**Subject** ▶ Change on pin 6 and screw M5x40

**For Models** ▶ 3612BR, 3612B, 3612BRA, 3600NB, 3600NBR (Router) and 9300 (Bench Grinder)

▶ Current	▶ New
<p>Pin 6</p>	<p>Cap 11 (added)</p>

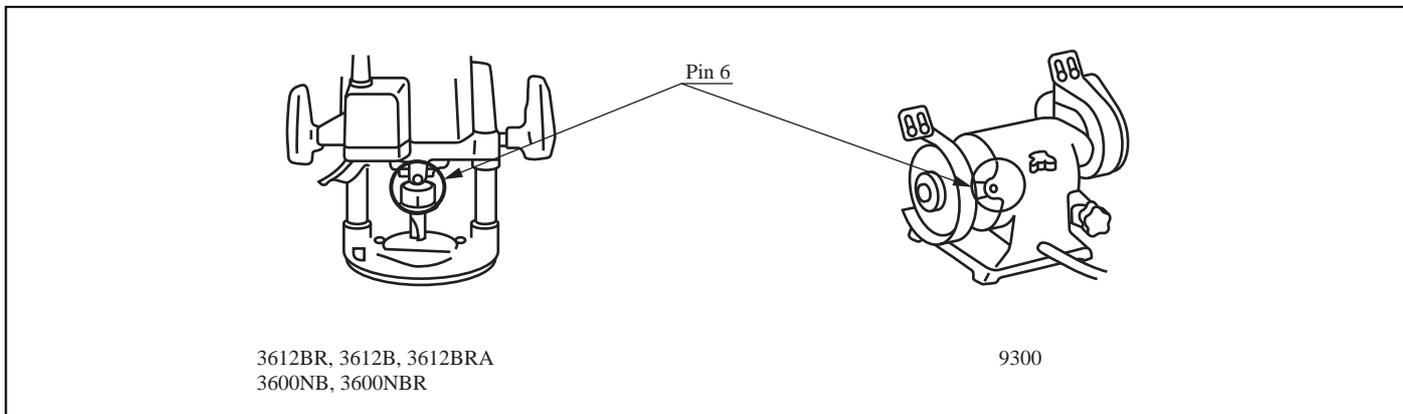
**Description** ▶ 1. A cap 11 will be added to the pin 6 (for shaft lock).

When you attach the cap 11 to the current type pin 6, always use adhesive (Three Bond 1521, etc.).
